UNITED STATES PATENT AND TRADEMARK OFFICE

APPLICATION NO.	FILING DATE	FIRST NAMED INVENTOR	ATTORNEY DOCKET NO.	CONFIRMATION NO.
10/718,593	11/24/2003	Helmut Schwarz	P24519	1224
7055	7590	07/05/2005	EXAMINER	
GREENBLUM & BERNSTEIN, P.L.C.			MITCHELL, KATHERINE W	
1950 ROLAND CLARKE PLACE			ART UNIT	
RESTON, VA 20191			PAPER NUMBER	
			3677

Office Action Summary	Application No.	Applicant(s)	
	10/718,593	SCHWARZ ET AL.	
	Examiner	Art Unit	
	Katherine W. Mitchell	3677

DETAILED ACTION

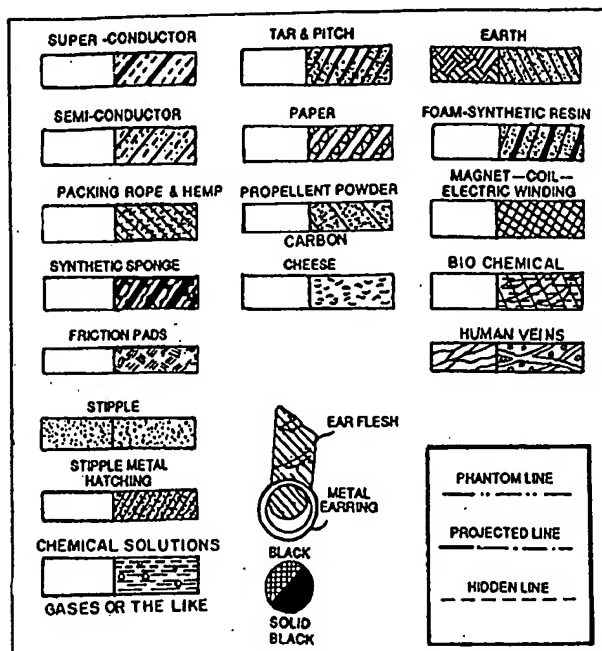
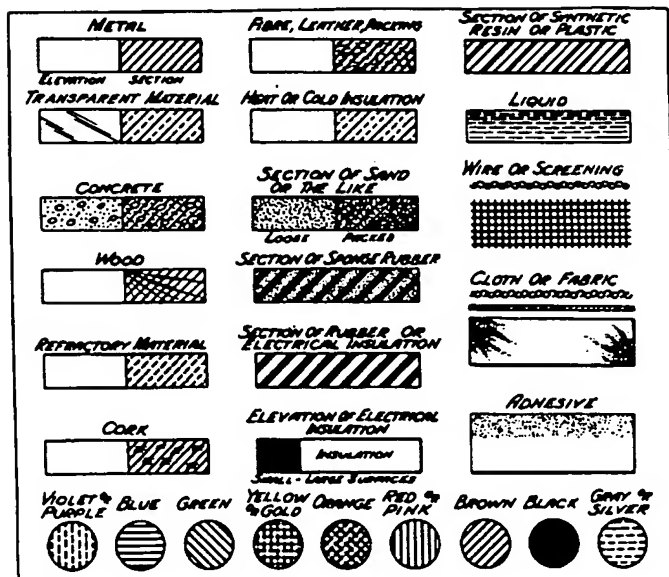
2. The drawings are objected to because the hatching in Figs 1 and 3 is improper.

Corrected drawing sheets in compliance with 37 CFR 1.121(d) are required in reply to the Office action to avoid abandonment of the application. Any amended replacement drawing sheet should include all of the figures appearing on the immediate prior version of the sheet, even if only one figure is being amended. The figure or figure number of an
